Santoft Groundwater Model and Rangitikei Groundwater Management Zone Allocation Limit Technical Review

Santoft Groundwater Model and Rangitikei Groundwater Management Zone Allocation Limit Technical Review

Dr Huma Saeed
Horizons Regional Council

Dr Hisham Zarour

Figure 3-4. Observed and model-calculated groundwater levels at Bore 312006 (from PDP, 2017).

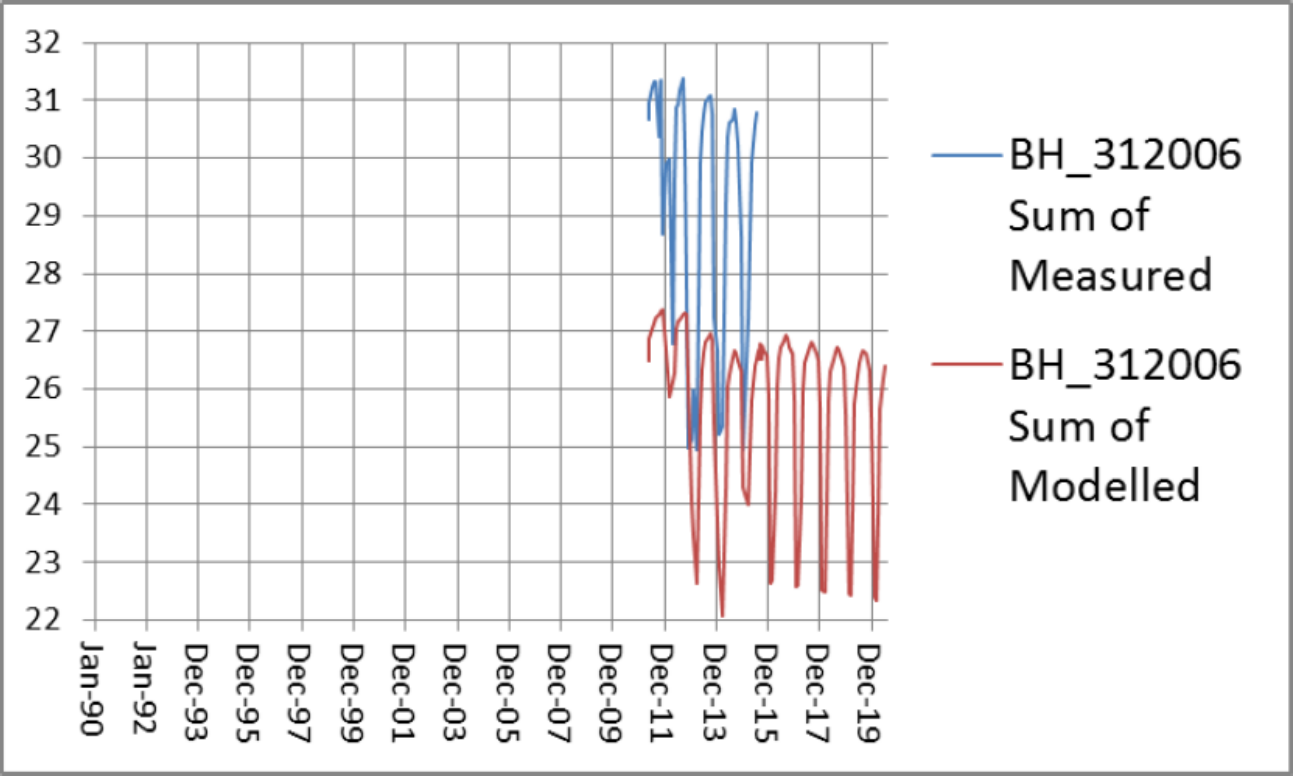
It is noted that groundwater level data from Bore 312006 (Figure 3-4) were excluded from the 2023 model despite being used in the calibration of the 2017 model. This change is not noted in PDP (2023) and no reason for the bore exclusion from the new model calibration is provided.

It is noticed that groundwater level data from Bore 312006 were used in the 2017 model (Figure 3-4). However, these data were excluded from the 2023 model. PDP (2023) does not note or justify this omission.

Figure 4-1. Transmissivity values from bores in the model (Figure 10 in PDP, 2017).

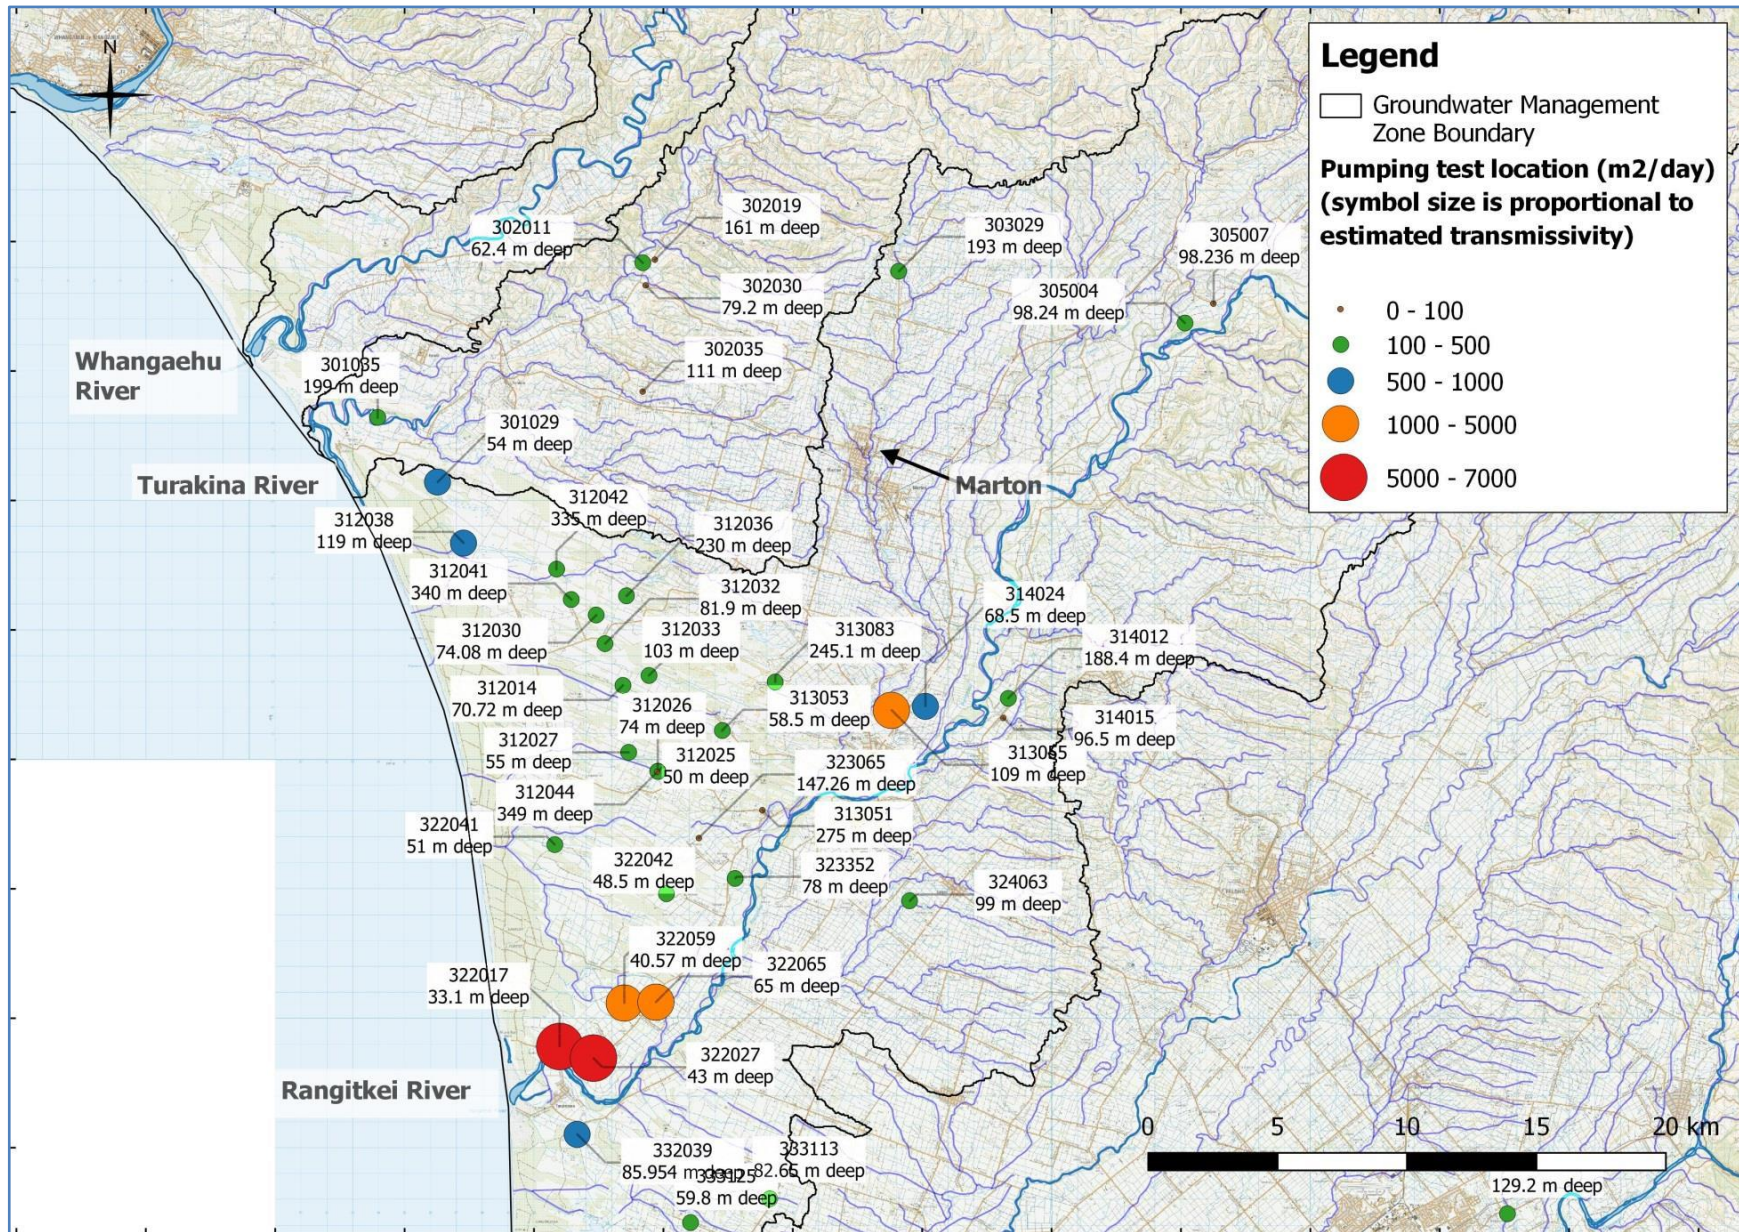
It is noted here that the map presentation of the K data in PDP (2017) is not adequately clear. It is also noted that few of the K value maps presented in Appendix B show bullseyes that could indicate unrealistic parameterisation and/or model calibration issues.

Some figures in the modelling reports must be re-designed. For example, the map displaying transmissivity values from pumping tests, presented as Figure 10 in PDP (2017), uses circles of proportional sizes to represent different value ranges, with divisions set at 0–100, 100–500, 500–1000, etc. However, this creates ambiguity for the reader, as it is unclear whether a value of 100 is represented by the 0–100 symbol or the 100–500 symbol. This example underscores the importance of thorough proofreading of the modelling reports, in addition to conducting technical model reviews, to ensure clarity and accuracy in data presentation.

Figure 4-7. Long-term plots showing the cumulative deviation from the long-term mean annual rainfall at selected sites (Figure 9 in PDP, 2017).

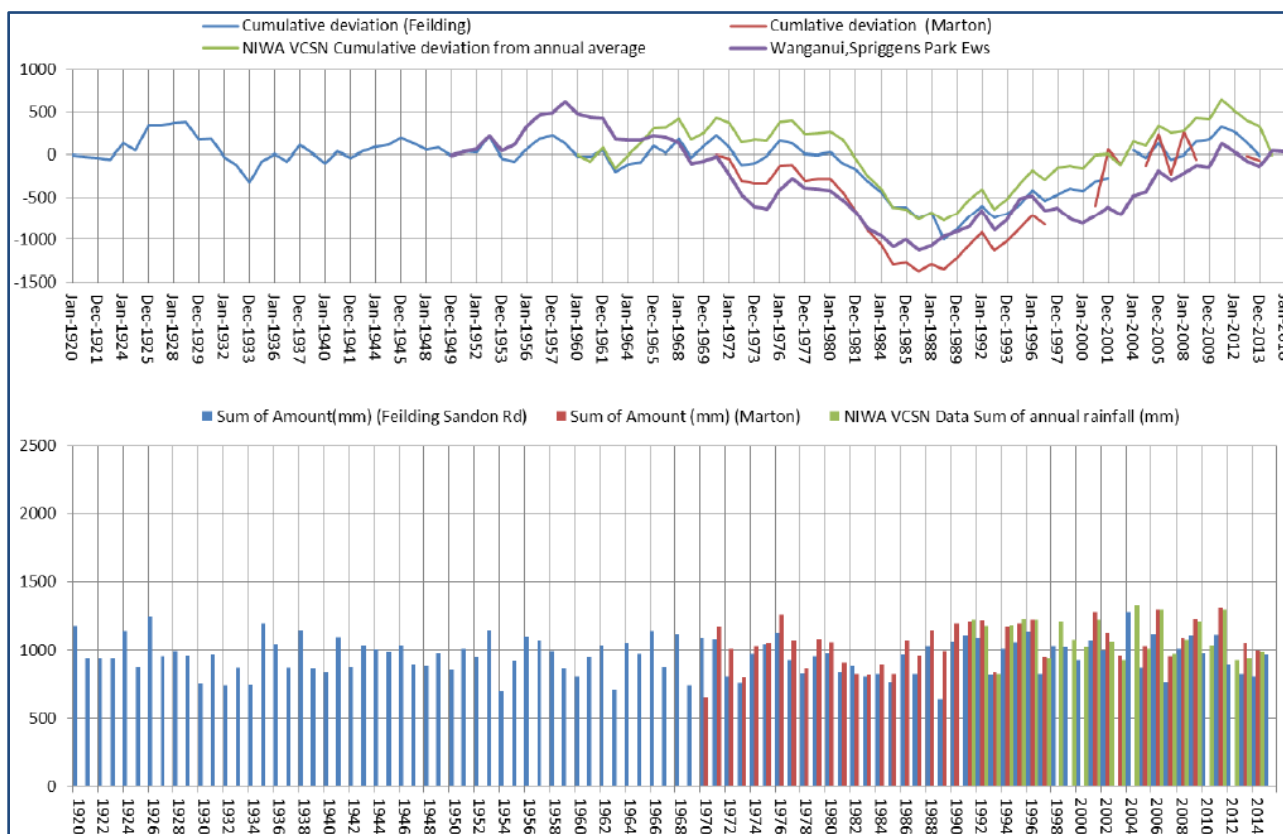
PDP (2017) use cumulative deviation of annual rainfall from the long-term mean (CDFM) to assess rainfall trends (Figure 4-7). The report suggests that the CDFM analysis indicates a 'stable pattern' from around 1935 to 1980, a 'declining pattern' between 1980 and 1989, and 'rising pattern' from 1990 to around 2011. The report argues that it is difficult to confirm the above hypothesis because the groundwater level records start from 1990. It also notes that the CDFM declining trend from around 2011 was not apparent in groundwater level data at the time of the report preparation. The report highlights that the noticed declining groundwater levels trend from 2005 cannot be related to the decline in rainfall from 2011.

Zarour (2018) calculated rainfall deviation against the cumulative mean, while PDP (2017) apparently calculated it against the simple arithmetic mean of the data from the start to the end of the record. Although both methods led to similar conclusions, the use of the cumulative mean is preferred. Using the cumulative mean ensures that data collected at a certain time are not compared with data from the future. For instance, rainfall in 2010 should be compared with the mean rainfall up to 2010, not against a long-term mean extending into the future, say to 2022.

Figure 4-9. Steady state recharge as assigned to the steady state stress period (1 July 1989–1 July 1990) in the 2023 model.

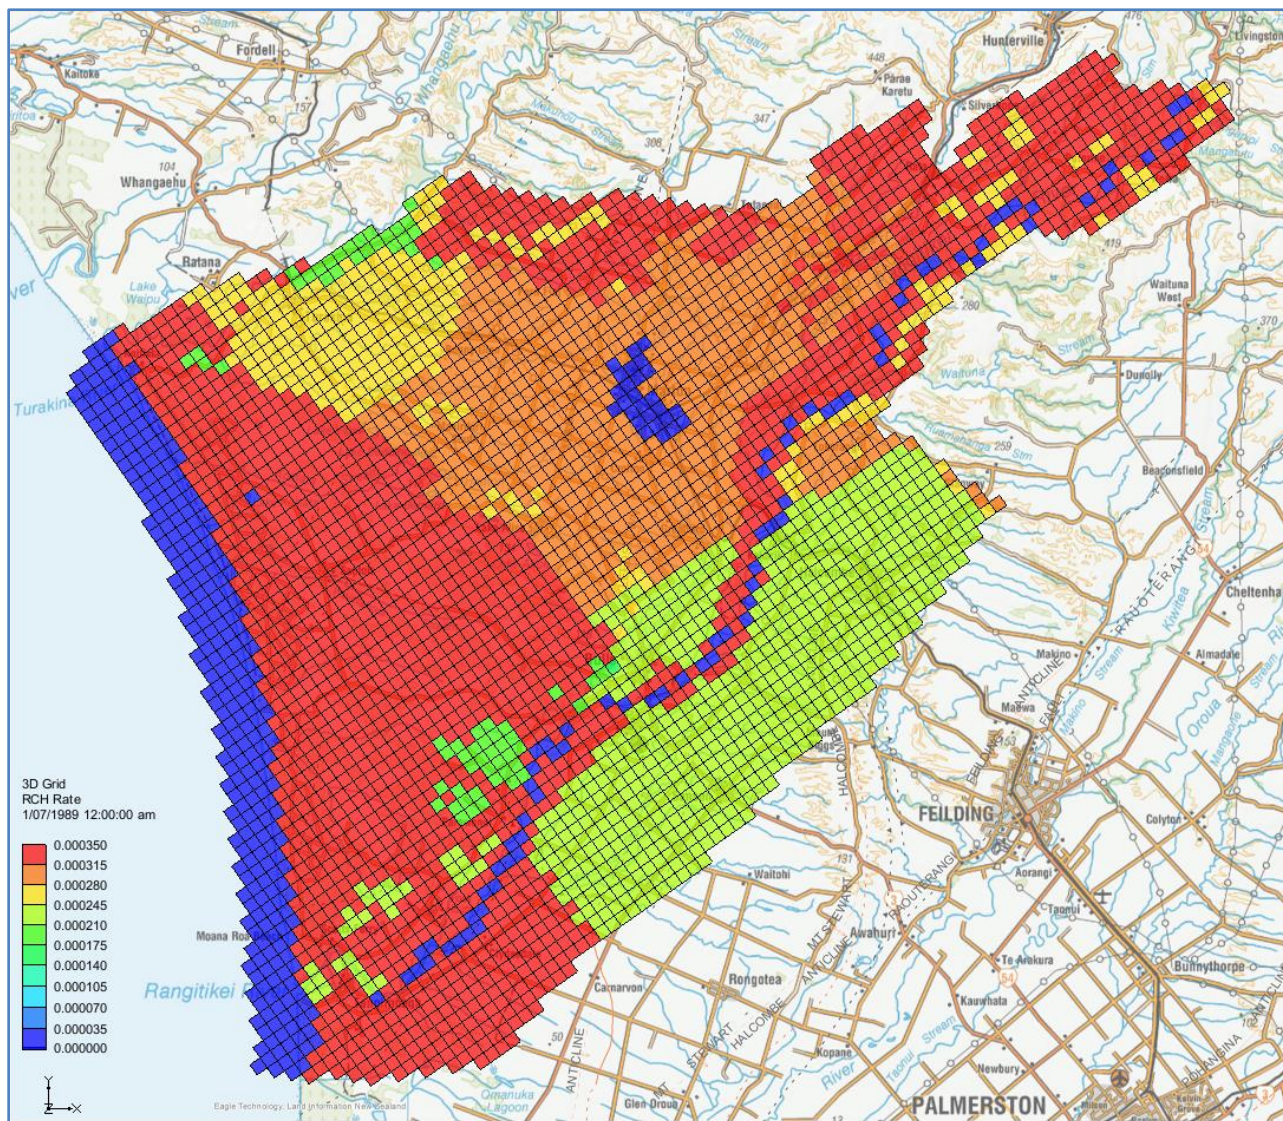
The steady state rainfall recharge assigned to the model varies across its domain from 0.00017411 m/d to 0.00034895 m/d, equivalent to 64 mm/y and 127 mm/y, respectively. This range is plausible. However, the map in Figure 4-9 shows relatively high recharge in cells also designated as drain (DRN) cells. According to Section 3.1 in PDP (2017), these cells are primarily located in the coastal area, where low vertical permeabilities and neutral or upward vertical hydraulic gradients imply limited infiltration to deeper strata, i.e., no recharge. No recharge is assigned in Marton Township cells, Lake Kaitiaki, and some cells along the Rangitikei River. Otherwise, relatively high recharge is assigned across the model domain. This contradicts the conceptualisation presented in PDP (2017) and PDP (2023) and is contrary to hydrogeological principles, as no rainfall groundwater recharge occurs on surface water features. Misimplementation of recharge in numerical groundwater models affects the reliability of their calibration since recharge is strongly correlated

Figure 4-10. Groundwater levels, electrical conductivity (EC), and water use data for the Hyde Park Farms consent (ATH-2006011251). Figure 3 in PDP (2023). Comment in red added as part of the review.

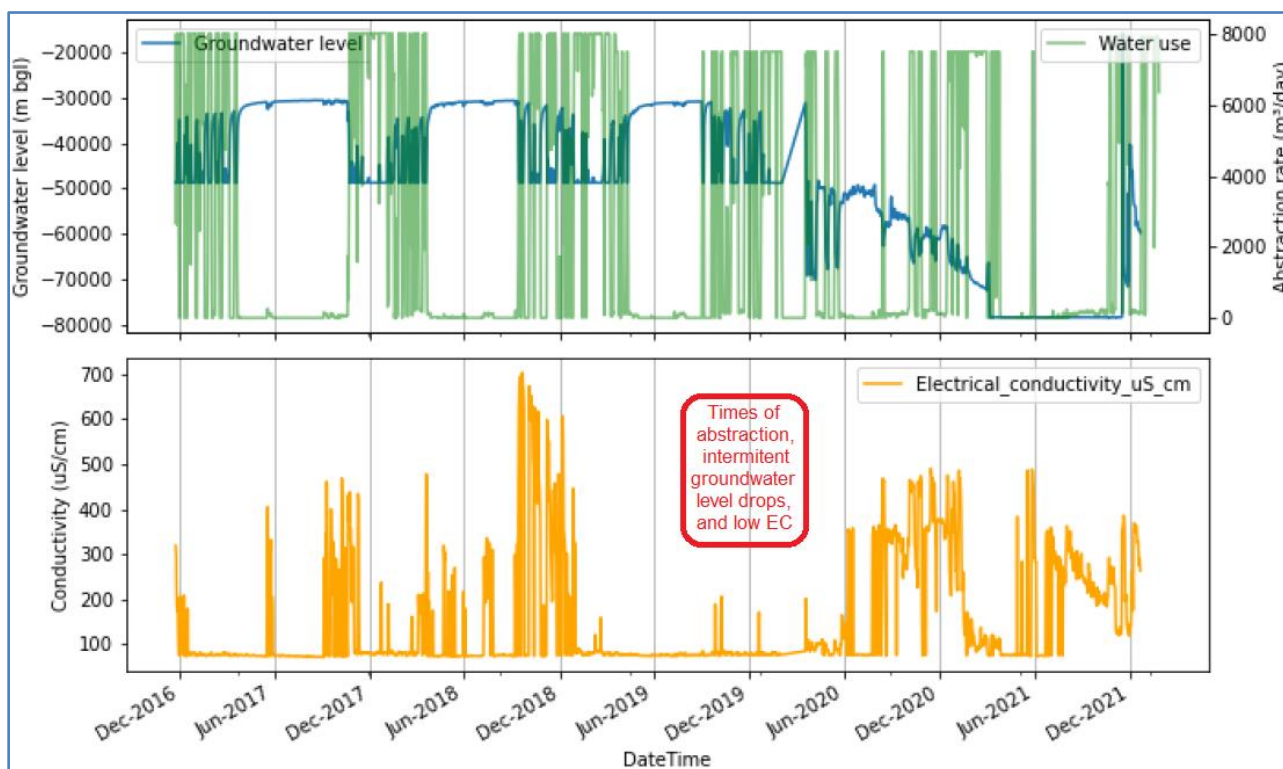
Section 2.1 in PDP (2023) attempts to relate changes in groundwater levels and electrical conductivity (EC)⁷ to abstraction. It further tries to explore inter-aquifer relationships (vertical flows through the system in the coastal area). However, some of the opinions offered in the report are not supported by the data presented. For example, the report claims that Figure 4-10 shows an inverse relationship between abstraction and EC. While the assumption is generally reasonable, it is not evident in the figure. There seems to be a problem with the monitoring instrumentation in the bore. Figure 4-10 suggests that in autumn and winter 2018, there is no pumping, the groundwater level is recovered, but there are EC spikes. The figure further shows that in the first part of 2019, groundwater level assumed to be drawn down by abstraction coincides with low EC. These observations contradict with the report's hypothesis that lower groundwater levels are associated with higher EC. There are additional issues with the monitoring record, including missing groundwater level data in 2021. Hence, no conclusions should be drawn from Figure 4-10 datasets until they are validated.

Figure 4-15. Rivers and streams in the area (blue lines) and river (RIV) cells in Layer 1 in the model (blue squares).

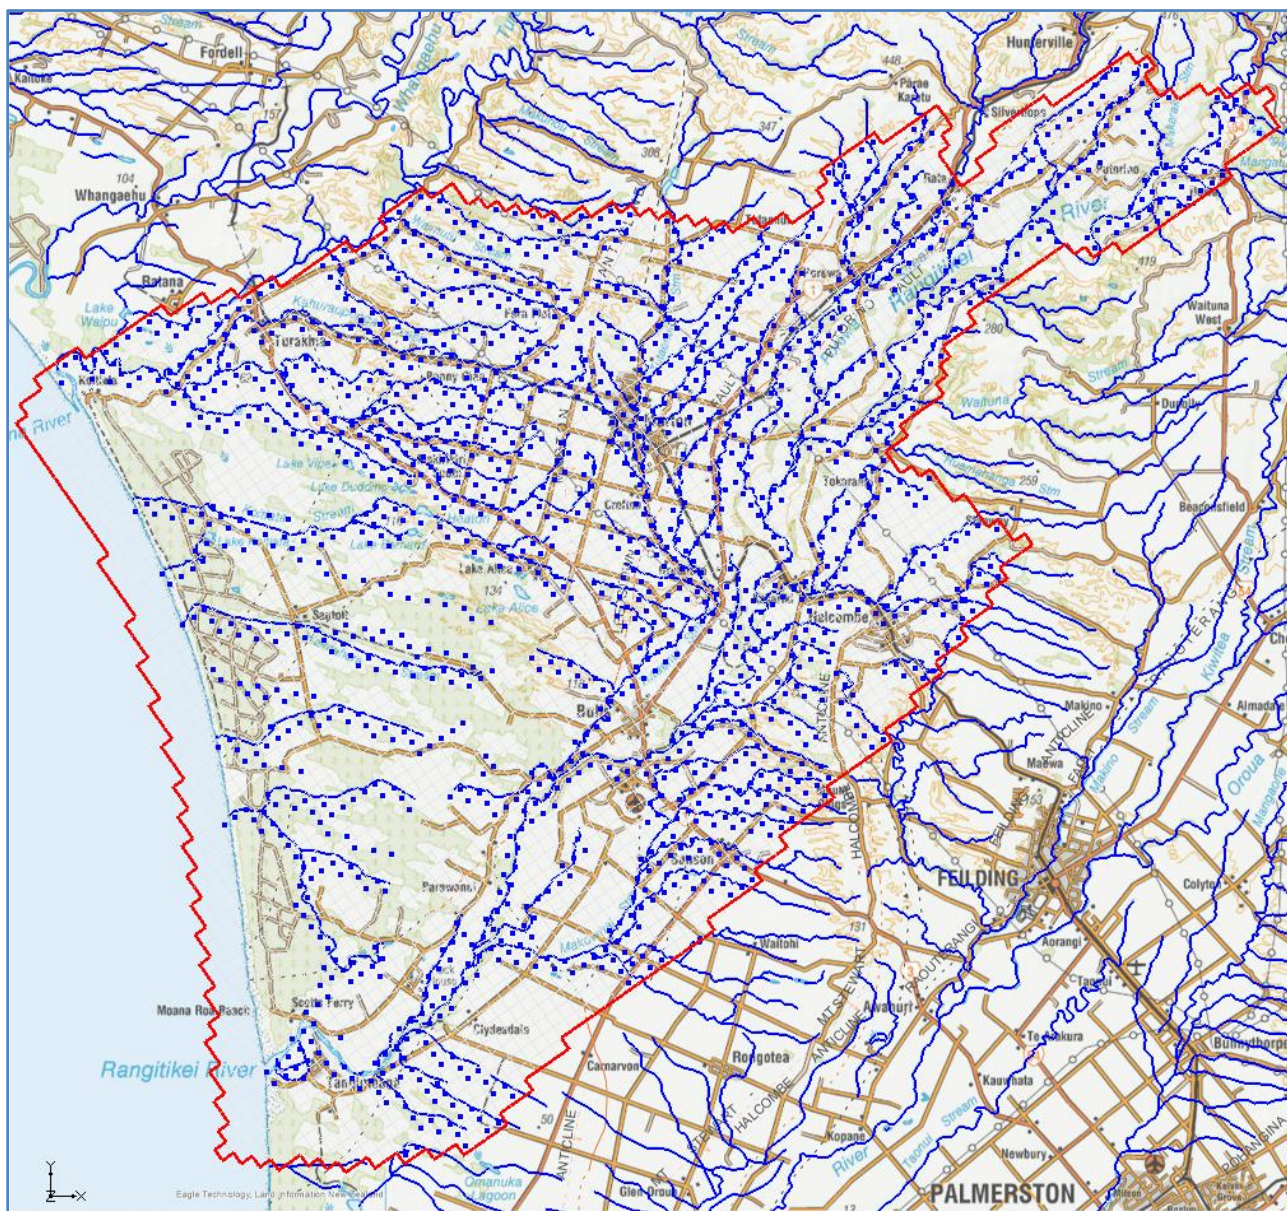
As mentioned above, there is an overlap of boundary conditions representing surface waterways in some cells in the model that can be problematic to the numerical models, making the models unrealistic and/or creating numerical problems. This is not noted in the reports or shown in Figure 14 in PDP (2017) reproduced here as Figure 4-35 but can be spotted from comparing Figure 4-15 and Figure 4-16.

Figure 4-21. Model vertical conductivity zones (Figure 17b in PDP, 2017).

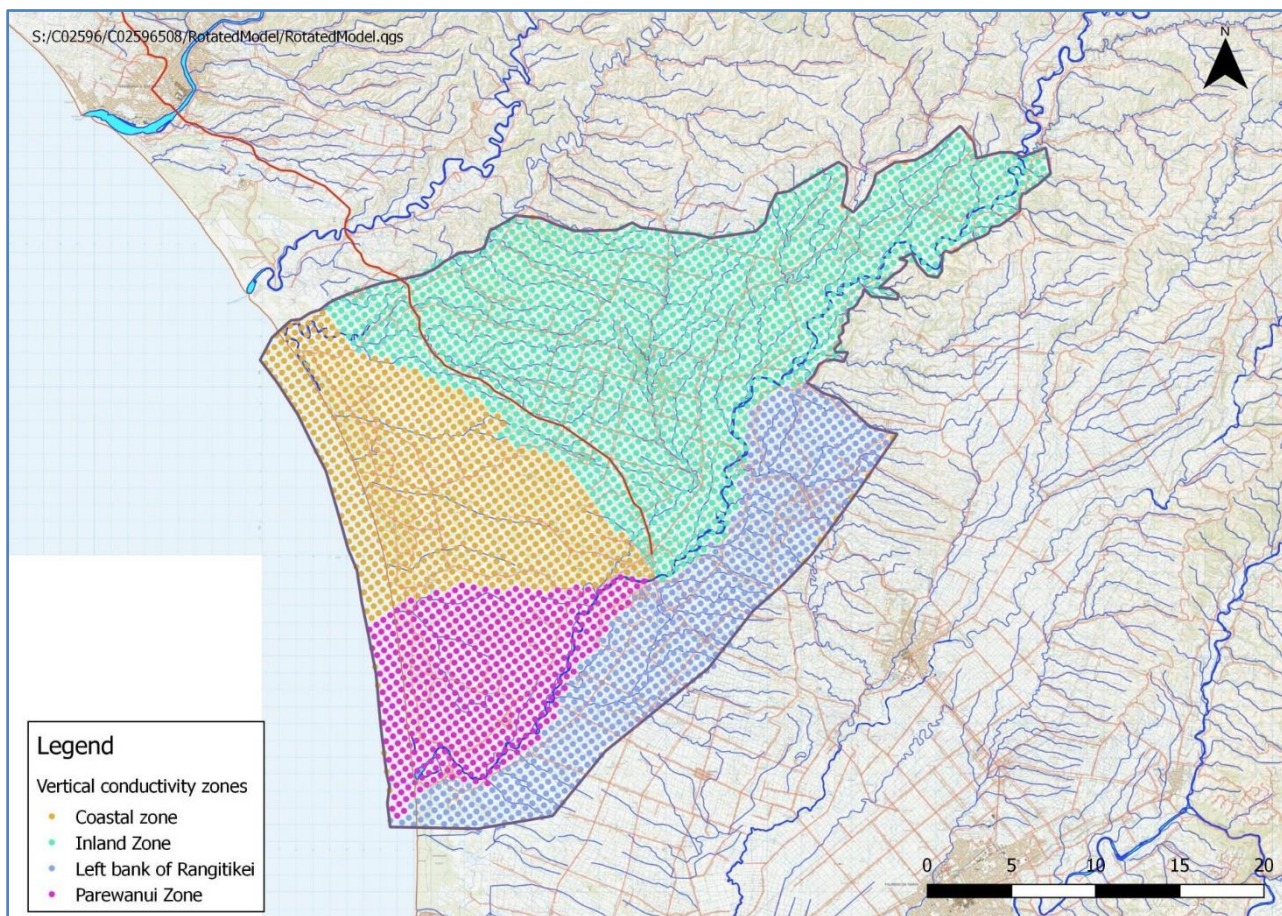
inland and where apparently higher values of leakage occur close to the true right bank of the Rangitikei River. The locations of those zones are shown in Figure 4-21. It is not known with certainty from PDP (2017) or the 2023 model data whether these zones were applied to all layers or to Layer 1 only. The report states that the zones were not set to different starting values in the PEST calibration process, and the vertical hydraulic conductivity values for all layers and zones were varied during the calibration process within a range of 1×10^{-3} and 1×10^{-6} m/d. The reason for setting zones that are all similar is not clarified.
